COMMUNITY BOARD FEEDBACK PACKAGE

Business Name: MAMA MIA 44 SW

Cafe Location: 621 9 AVENUE, NEW YORK, NY, 10036

Application Number: 20240731010087

Roadway Cafe Site Plan Form

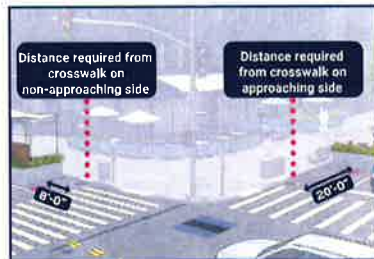
MCB4 recommends approval with one open issue. Section 5-11(b)(1)(ix) of the Dining Out NYC rules provides that any elements of a roadway cafe located within 50 feet of "any regulatory or warning signs" shall be no greater than 46 inches in height. The establishment at issue here is located on the corner of West 44th St. and Ninth Ave., with the proposed roadway cafe on the West 44th St. side. On the Ninth Ave. side of this corner, there is a sign stating "This Is a Gun Free Zone." Does the nature and placement of that sign on Ninth Ave. affect the proposed roadway cafe on West 44th St.?
